# City of Alexandria, Virginia

## MEMORANDUM

SUBJECT: 700 SOUTH WASHINGTON STREET & 600 FRANKLIN STREET,  
BAR CASE #2013-00210

**600 FRANKLIN STREET 700 S. WASHINGTON -- ALEXANDRIA, VA**  
Comprehensive Sign Plan

**S WASHINGTON STREET: 1A**

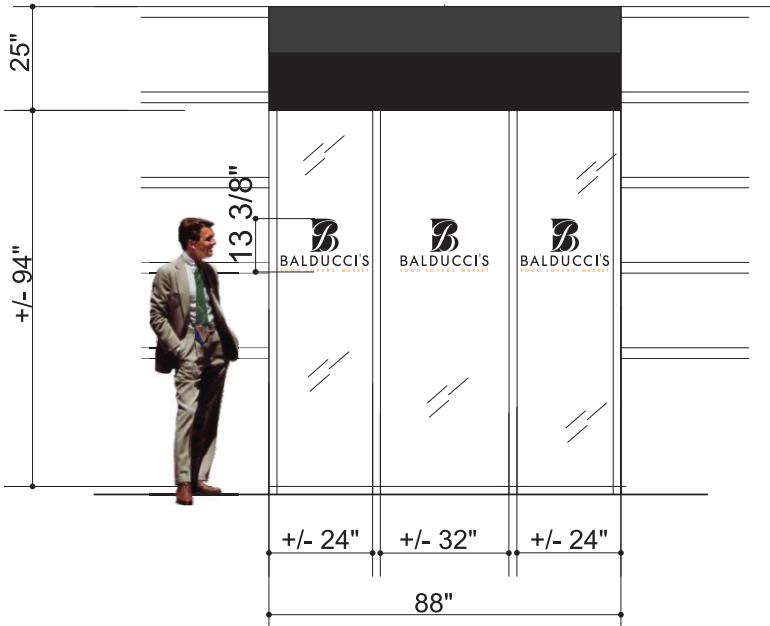
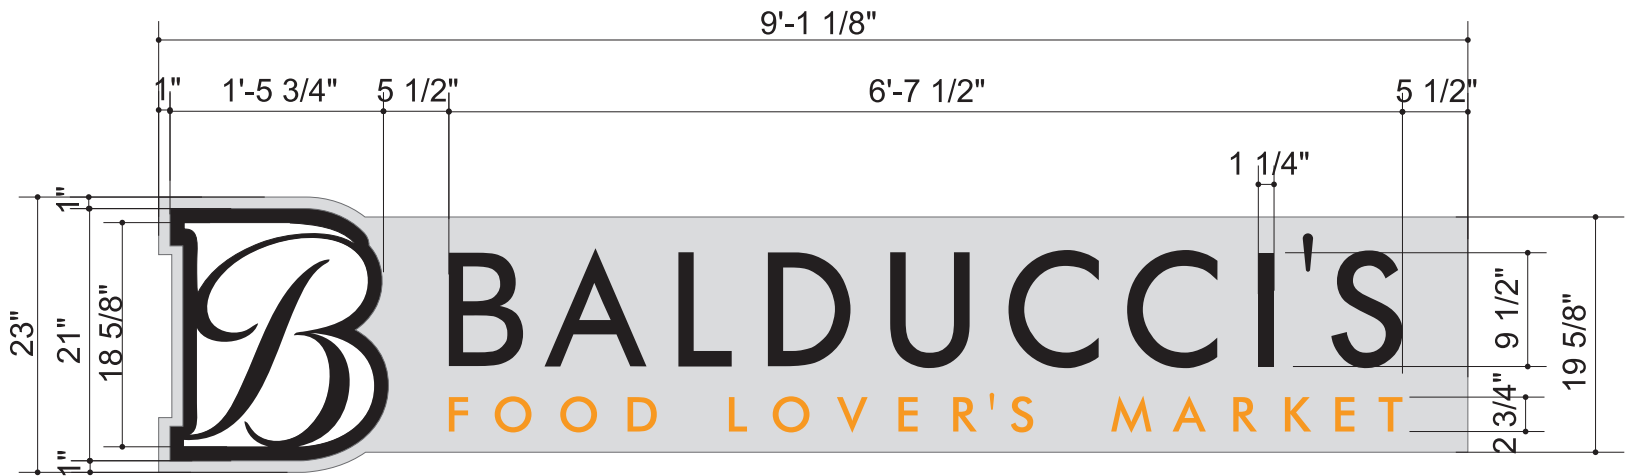
- Request for three window decal graphics for each of the two Washington Street retail spaces, up to two square feet each.
- Request for each tenant will be able to select its own awning color. The Balducci's space will continue to have black awnings and the John Marshall Bank proposes navy blue awnings.

While some window decals are acceptable, staff is concerned about the number proposed in this application (six on South Washington Street and 12 on Franklin Street). In order to limit visual clutter, staff recommends that the number of decals be limited to one per retail space on Washington Street and two per retail space on Franklin Street. Staff finds it preferable to have fewer and slightly larger decals rather than the proposed number and size.

5. RETAIL TENANT  
A. BLADE SIGN MOUNTED TO  
BUILDING FACADE ABOVE MAIN ENTRY

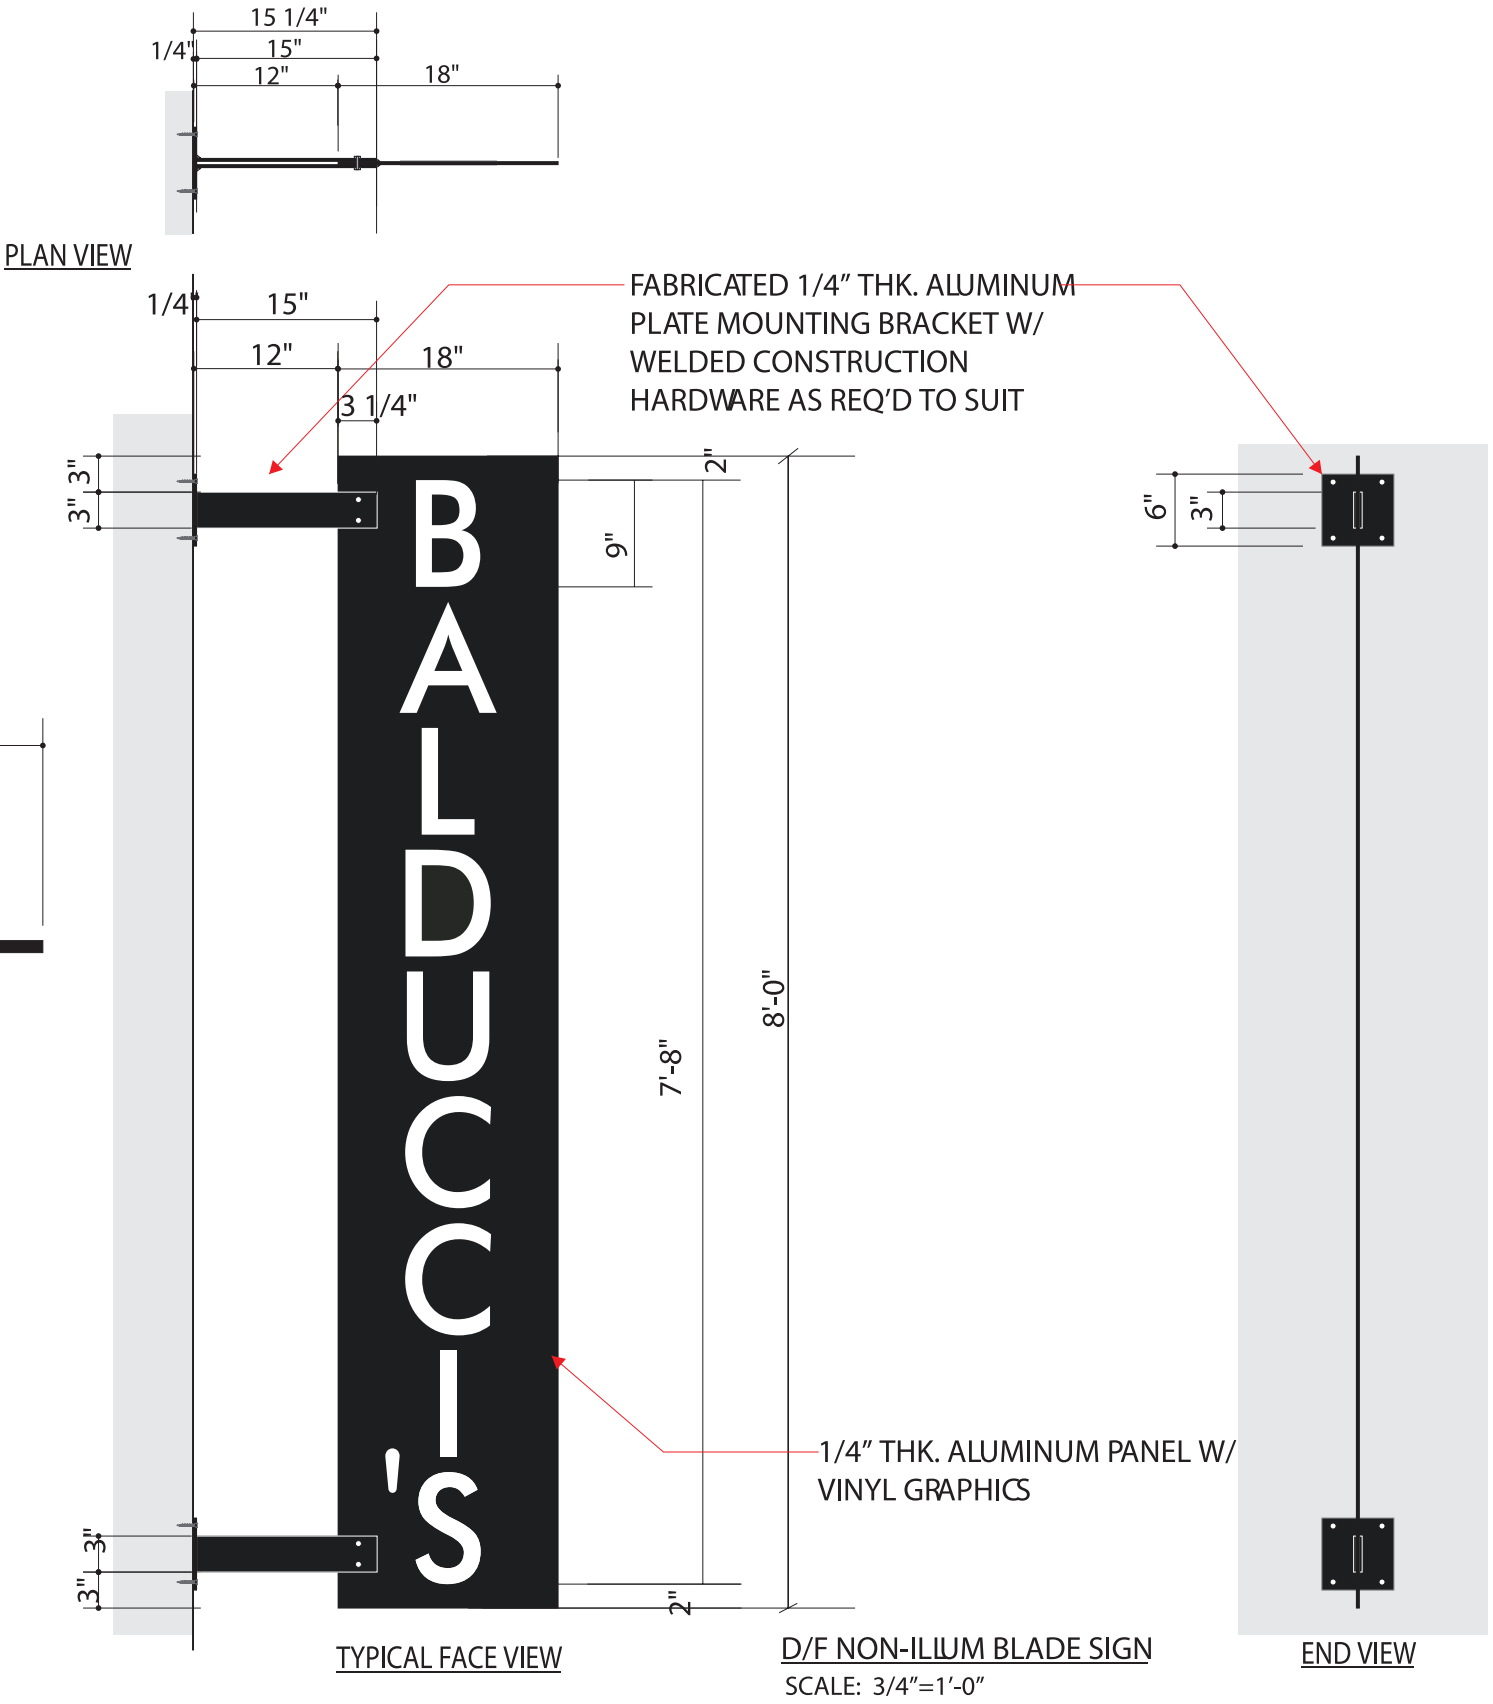
Staff supports the proposed blade sign on Franklin Street for “Balducci’s” and the elimination of the wall sign at the prominent corner with Washington Street. The National Park Service was most concerned with this aspect of the original application and now has no objection to the proposal.

5. That a single blade sign for this building is permitted only on Franklin Street and is only appropriate for a large, primary retail tenant, such as Balducci's. The sign must be located adjacent to their main entrance.

**1. 3RD FLOOR TENANT (TBD)**  
UP TO 50 SF MAXIMUM ALLOWED FOR FULL 3RD FLOOR TENANT  
IF SMALLER TENANT RATIO IS 1/2 SF FOR EACH FOOT LINEAR FRONTAGE  
ALUMINUM DIMENSIONAL LETTERS MAX 3" THICKNESS  
MOUNTED TO BUILDING FACADE  
TENANT NAME (NO LOGO)

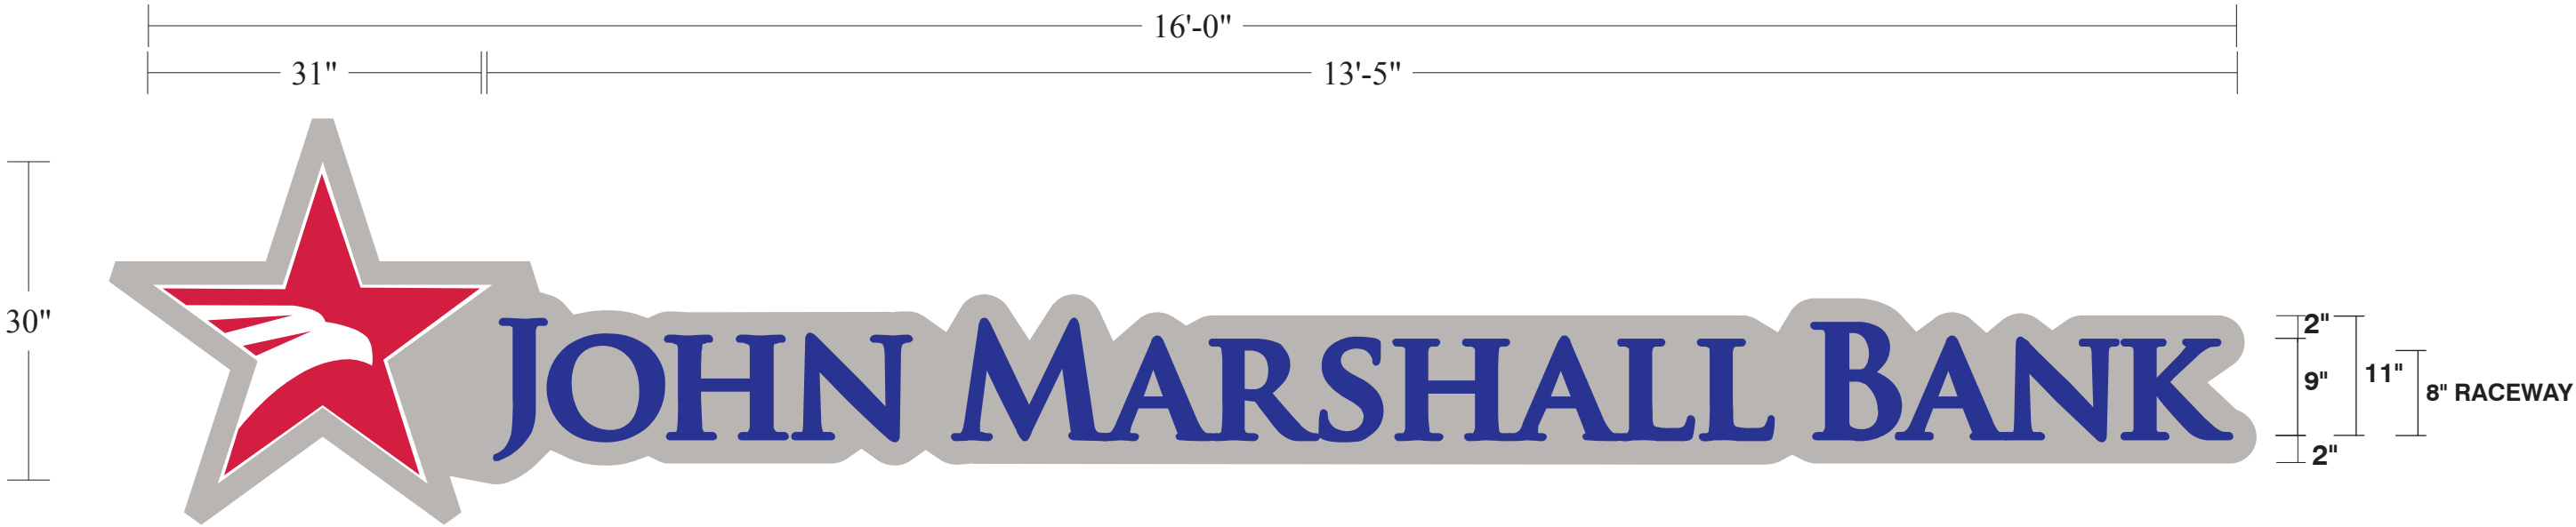
Staff does not support the proposed placeholder for signage for a third-floor tenant below the cornice. In looking at the building, due to the brickwork and small area between the cornice and third floor windows, there is inadequate space to install such a sign. Further, as the Board clarified during the recent building naming signs proposed at the Saul Center, such signs at the top level of large buildings such as this are intended to be building identification signs that effectively name the building, not merely advertising for one of many tenants. The National Park Service noted in their comments for this case that "in all the documents we've seen regarding what the MVMH/GWMP was trying to achieve in creating a roadway with a memorial character was not a commercialized Route 1 corridor that existed at the time, but a more solemn, historic, scenic road that celebrated the natural environment as well as the historic built

S WASHINGTON STREET: 3

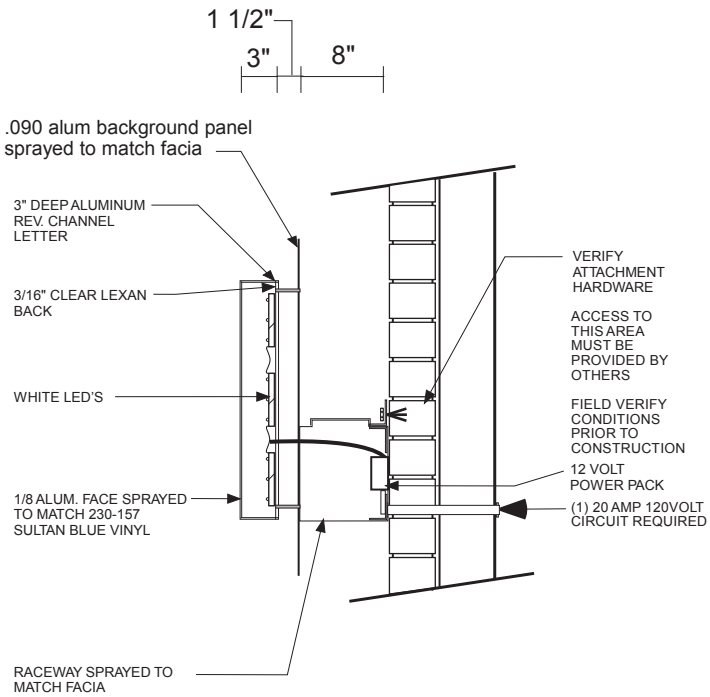
The proposed signage for the bank, located at the corner retail location, is not appropriately located and is out of scale with the building. While a corner tenant is typically allowed up to three signs, Staff finds that the two illuminated wall signs and various decals need further refinement. Upon initial review of the submission, Staff advised the applicant that the two wall signs should be reduced in size and relocated under the keystone and between the piers. The current location completely disregards the existing architectural keystones over the window and door openings throughout the building. The star is almost three feet tall, extending above and below the 30” tall stone lintel, and projects over a foot from the face of the building wall.

There is no doubt that the bank should have some signage on both elevations of its corner location and Staff fully supports a scheme that is integrated with the architecture of the building. An appropriate scheme for this building would include a smaller wall or awning sign within the

**6. RETAIL TENANT MAX 98 SF (BALDUCCI'S)**  
**-- A. LOGO SIGN MOUNTED TO BUILDING FACADE**  
12 SF BOX SIGN WITH RETAIL TENANT LOGO  
MOUNTED TO BUILDING FACADE  
IMAGE ABOVE SHOWS APPROXIMATE SCALE OF SIGNAGE

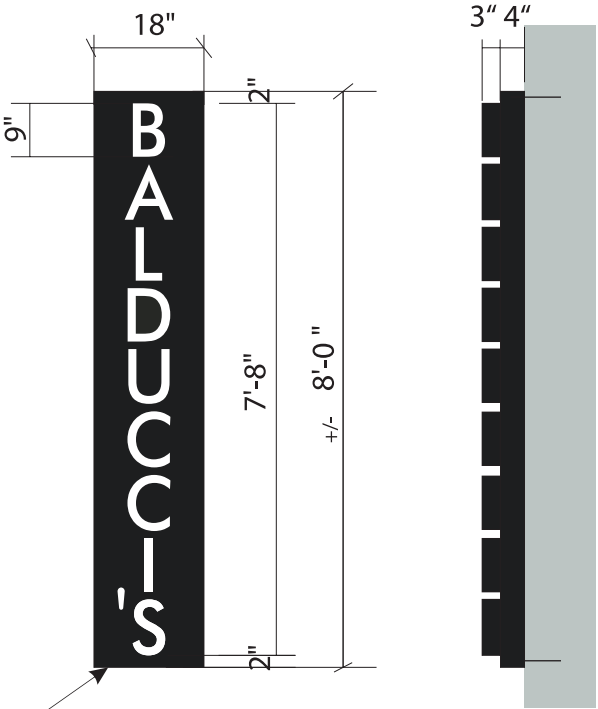
The proposed upper-story vertical wall sign for Balducci's, in addition to the existing ground-floor signs to remain, is more extensive than that typically found for a single tenant on a large commercial building. At the request of BAR staff a few years ago, Balducci's removed an illegal freestanding sign that was located directly on Washington Street. Over the past several months, Staff has suggested that Balducci's consider a blade sign located near the entrance on Franklin Street. The wall sign now proposed will have limited visibility from several directions and is not located near the entrance of the grocery store. The zoning ordinance requires that signs be located adjacent to tenant space. Staff does not object to the size or scale of the wall sign but recommends it be converted to a blade sign and that it be relocated on a pier immediately adjacent to the Balducci's entrance on Franklin Street. It should also be noted that the existing "For Lease" signs on the corner piers are not in conformance with zoning ordinance requirements. The size and location of these signs are awkward and further illustrate why a vertical wall sign for Balducci's should not be located here.
